RECEIVE AND FILE COMMUNICATION FROM THE PLAN AND ZONING COMMISSION REGARDING PRELIMINARY PLAT "BEAVER COVE" ON PROPERTY LOCATED AT 4209 LOWER BEAVER ROAD

RE: Beaver Cove Townhomes - Preliminary Plat & Development/Site Plan – 4209  
Lower Beaver Road

**BEAVER COVE  
DEVELOPMENT/SITE PLAN**

SHEET NUMBER:  
**C2.1**

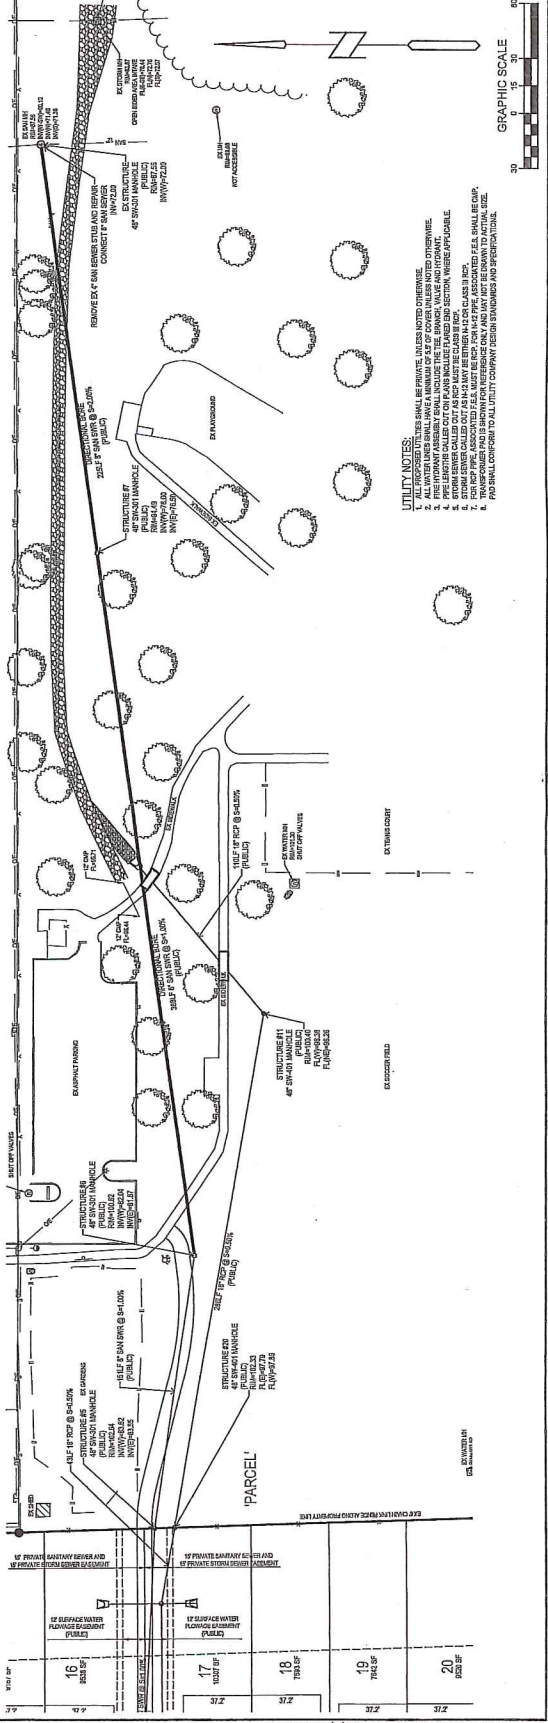
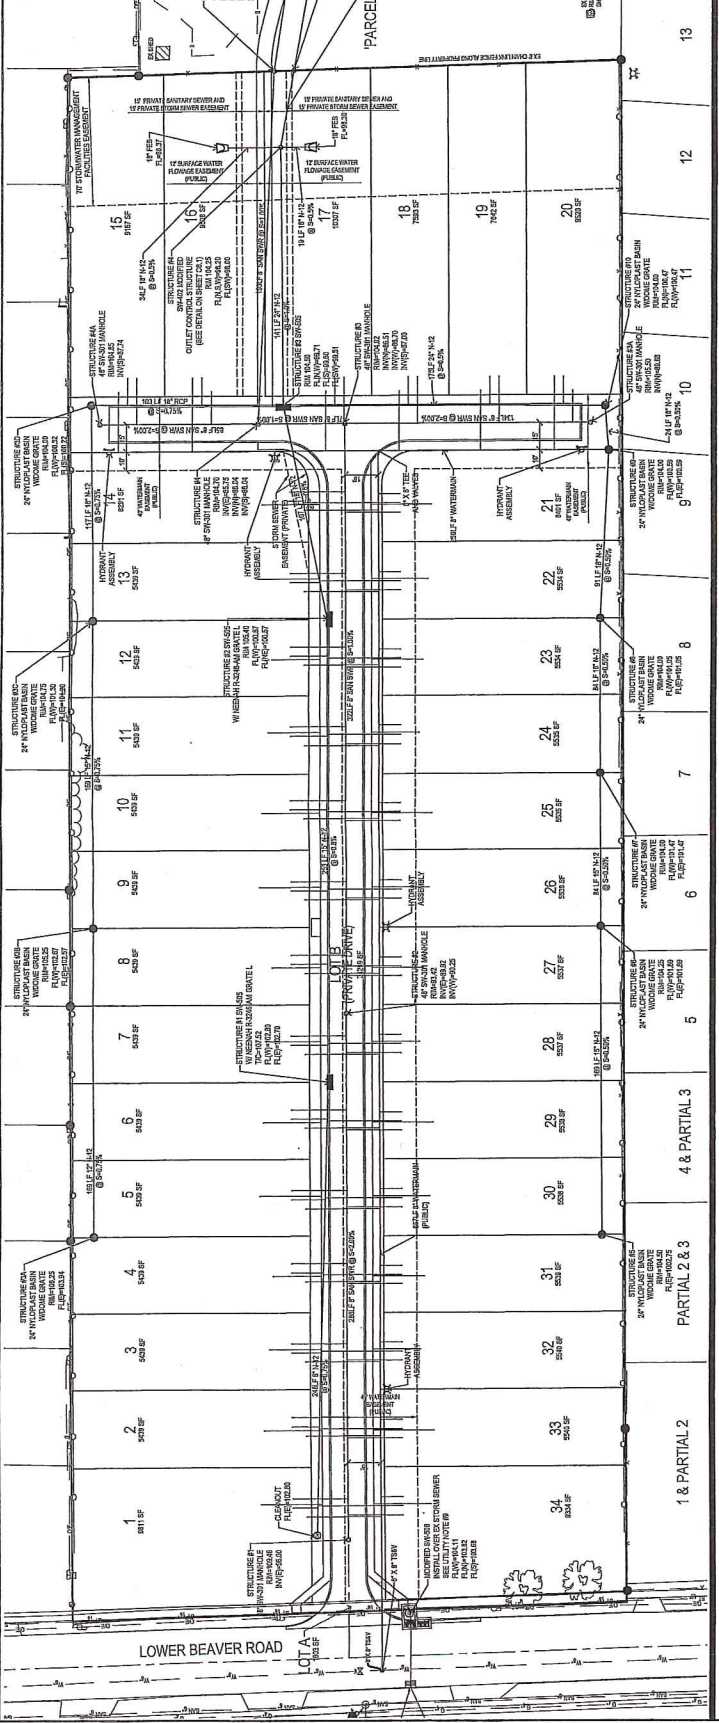
- Continue the connection to the park in a consistent 8-foot width for the full length. The route can be straight, no need to curve/bend.
- Provide more detail on the look and materials proposed for the storm outfall in the Park shown on C2.1.

**UTILITY PLAN**  
**PRELIMINARY PLAT**  
**BEAVER COVE**

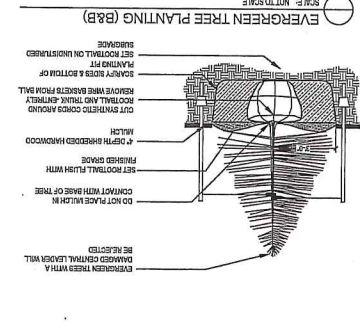
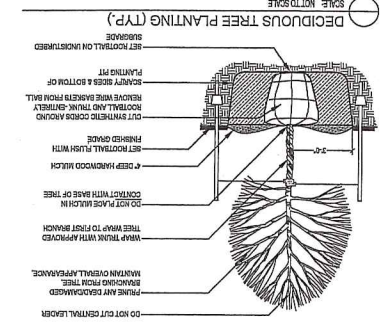
2. PLAT BOUNDARY -- Add bearings and label the POB.
3. GRADING PLAN – Add FFE for dwellings and garages.
4. UTILITIES –
  - Is the 8” sanitary sewer in the plat to be public or private? It is not clear. Please label.

- Dimension the offset between sewer and water main within the plat.
  - Explain the reason for locating MH #5 south of the pathway. Due to the depth of the sanitary sewer we will require a minimum separation of 15 feet between private and public piping.

- Add a notation to require a minimum of two feet of cover for the 30” RCP arch pipe.
  - The weir plate in the outlet structure is not specified. Also, a circular orifice would be much easier to create. Why was a square hole chosen?

- Is it intended that Lot A, Private Drive would also serve as easement area for public sanitary sewer and water?
- If the sewer from MH #4 to MH #5 is to be public, we will require a minimum easement of 15 feet each side of pipe.
- Please enlarge the text label of the Stormwater Management Facilities Easement area and submit a legal description of the same.

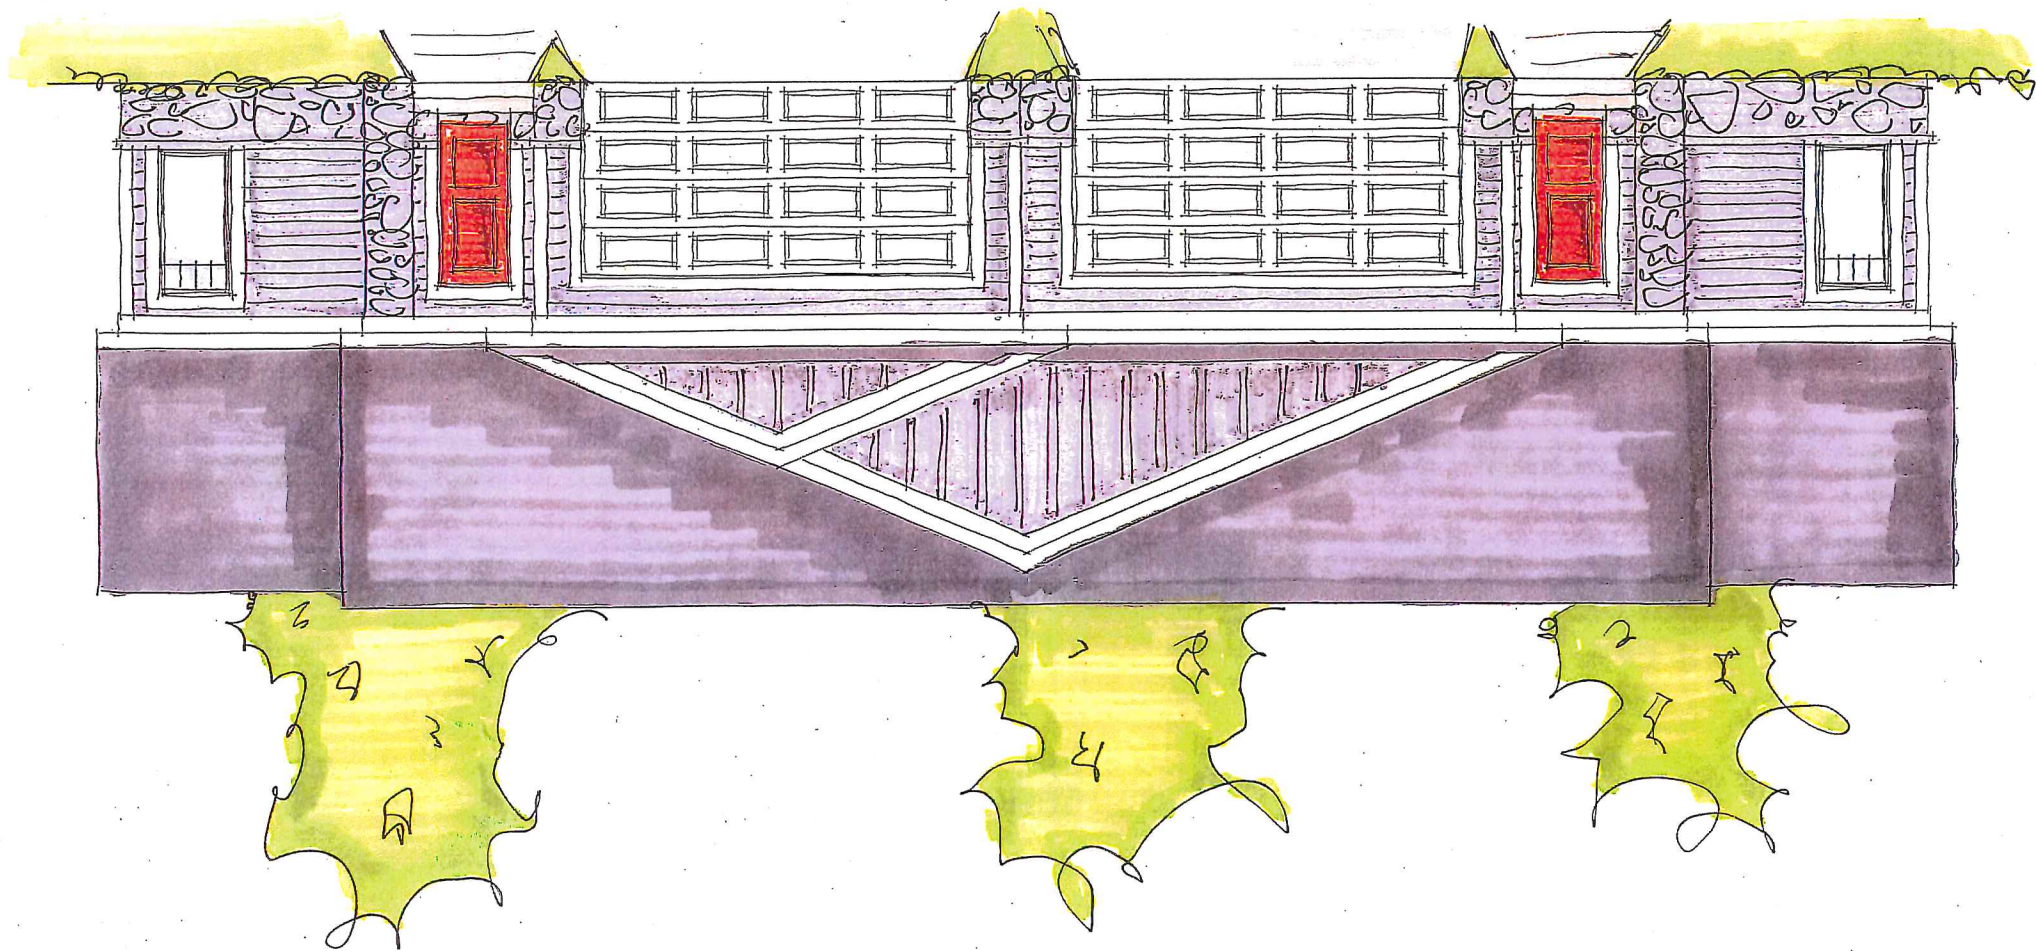
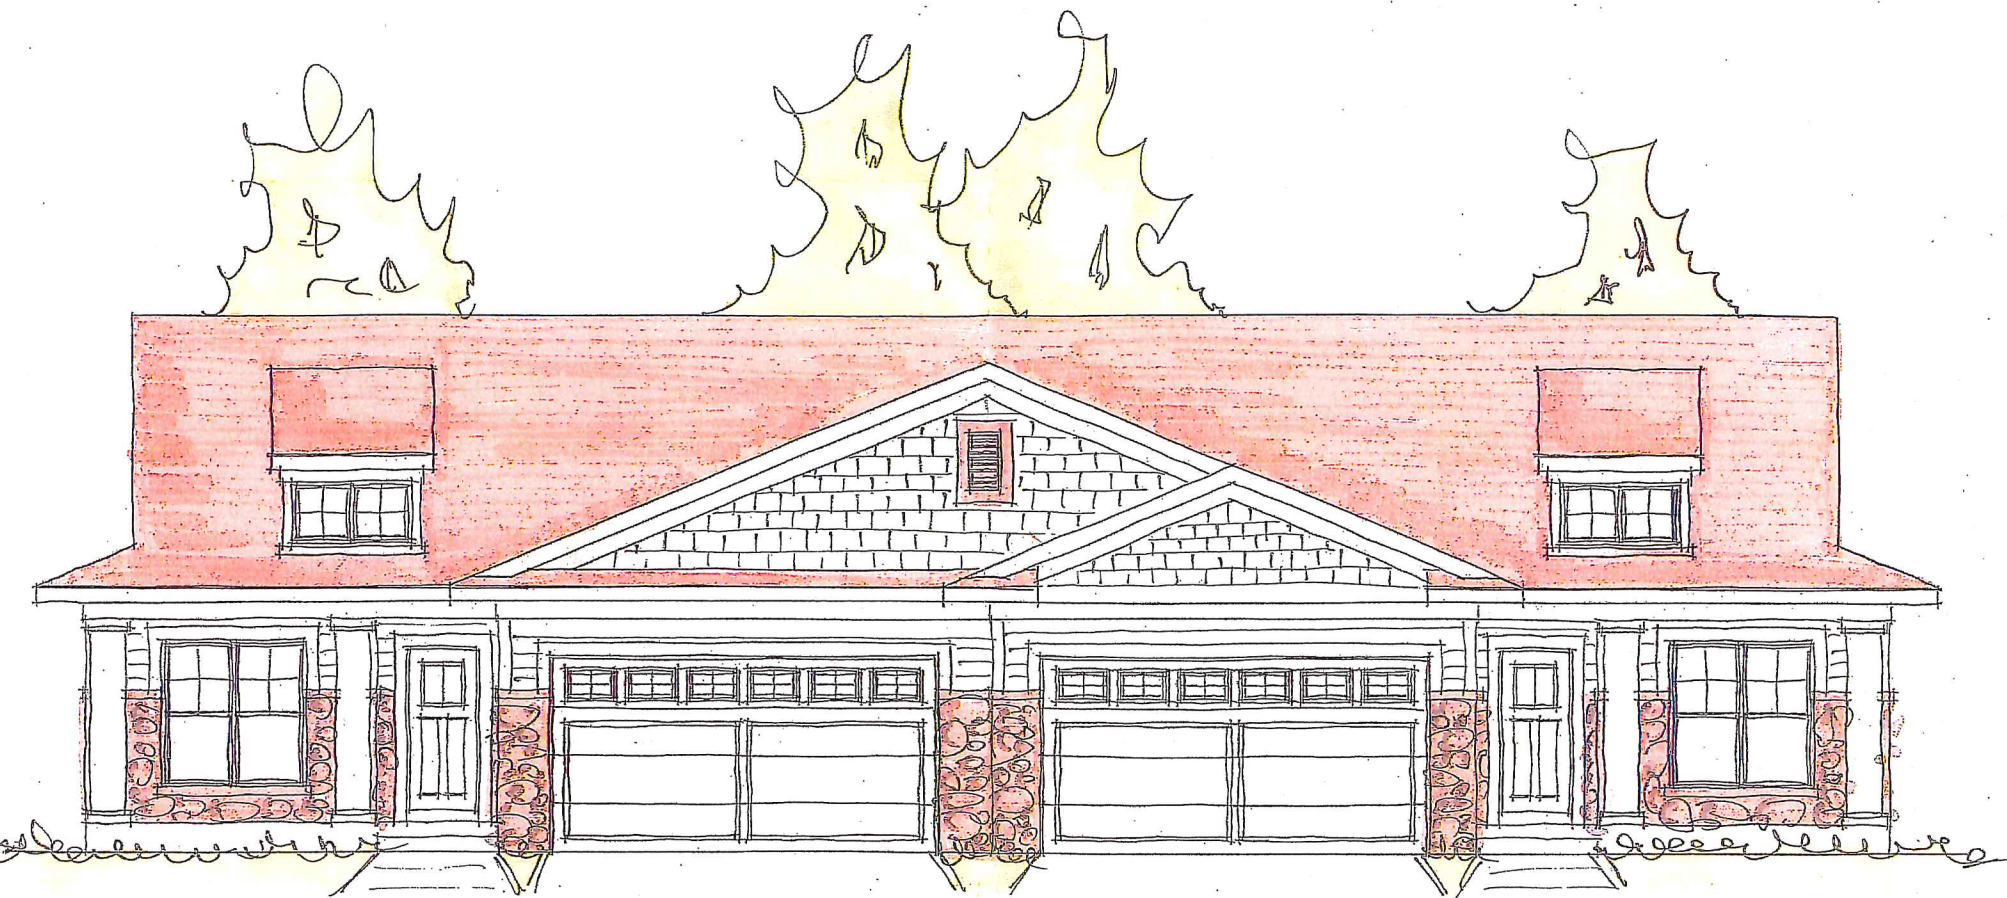
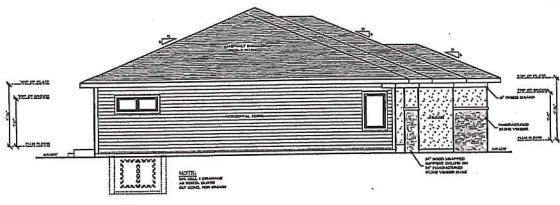
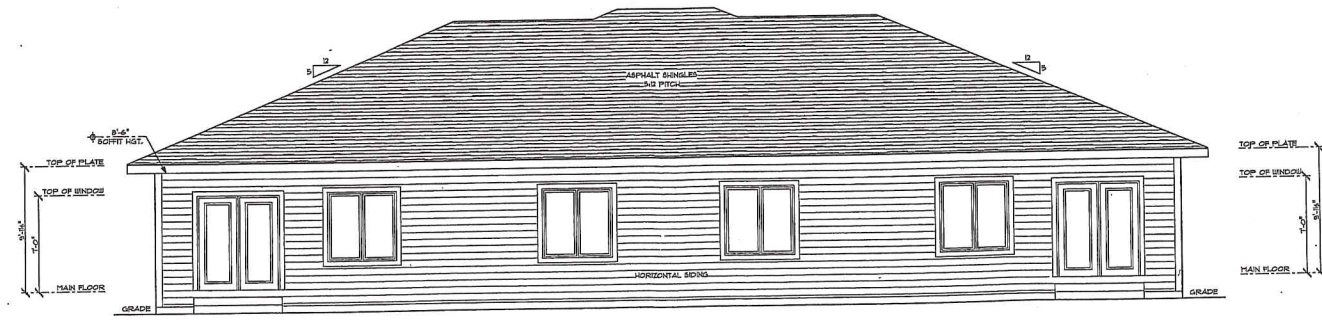
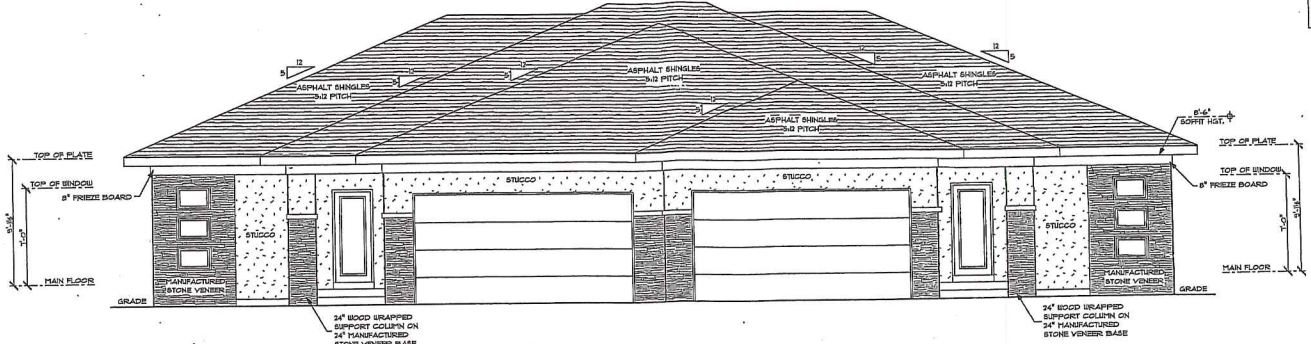
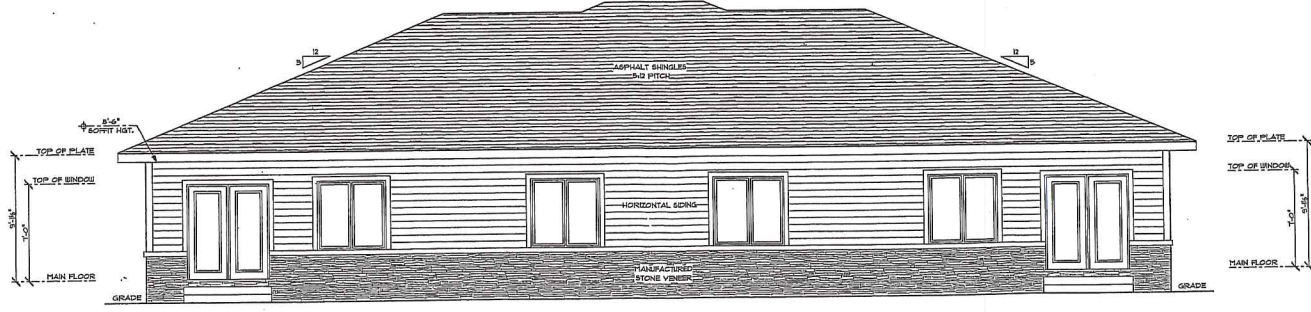
2. Provision of window lights within the overhead garage doors of all the single-family semi-detached dwelling design options.

That there be windows on the upper level of all the garage doors.

David Bentz Bishop Engineering 3501 104<sup>th</sup> Street, Urbandale, IA stated he agrees to staff recommendation and the windows on the upper level of all the garage doors. They worked hard to comply with everything that was asked of them at the last Plan and Zoning Commission meeting.
